Access Compliance Report

Public Rights-of-Way

Intersection ID: 49803	Main Street: ATKINS_RIDGE_DR	Cross Street: MATARESE_CT	Location:	E
ADA ID: A2A38836E1F7	Ramp Type: PerpDiag	Initial Pass/Fail: Fail	Overall Compliance: No	Severity Score: 22.5
Codes/Mitigation Info/Possible Solution		Field Measurements/Component Compliance

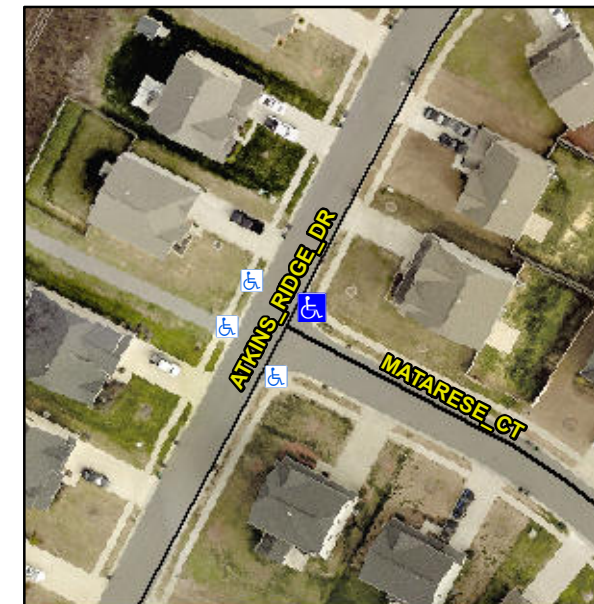
Not Found, R304.5.1, R304.2.2, R304.5.3

Compliance	Description	Data	Compliance	Description	Data
N/A	Ramp Length (in)	49.0	No	Ramp Slope (%)	10.8
No	Ramp Width (in)	45.0	No	Ramp XSlope (%)	2.2
N/A	Flare Type LT	N/A	N/A	Flare Type RT	N/A
N/A	Flare Slope LT (%)	N/A	N/A	Flare Slope RT (%)	N/A
N/A	Flare Traversable LT?	N/A	N/A	Flare Traversable RT?	N/A
N/A	Landing Length (in)	N/A	N/A	DWS Provided?	N/A
N/A	Landing Width (in)	N/A	N/A	DWS Contrast?	N/A
N/A	Landing Slope (%)	N/A	N/A	DWS Length (in)	N/A
N/A	Landing X Slope (%)	N/A	N/A	DWS Full Width?	N/A
N/A	Landing Curb? (Y/N)	N/A	N/A	DWS Offset (in)	N/A
N/A	Shared Landing?	N/A			
N/A	Gutter Ponding?	N/A	N/A	Gutter Slope (%)	N/A
N/A	Gutter Lip Ht (in)	N/A	N/A	Gutter X Slope (%)	N/A
N/A	Painted X Walk1?	No	N/A	Painted X Walk2?	No
	X Walk 1 Direction	To NW		X Walk 2 Direction	To SW
N/A	X Walk 1 Width (in)	N/A	N/A	X Walk 2 Width (in)	N/A
	X Walk 1 Slope (%)	1.6		X Walk 2 Slope (%)	2.6
	X Walk 1 X Slope (%)	2.6		X Walk 2 X Slope (%)	0.1

Remove & Replace Curb Ramp With Two New Directional Ramps or Equivalent.
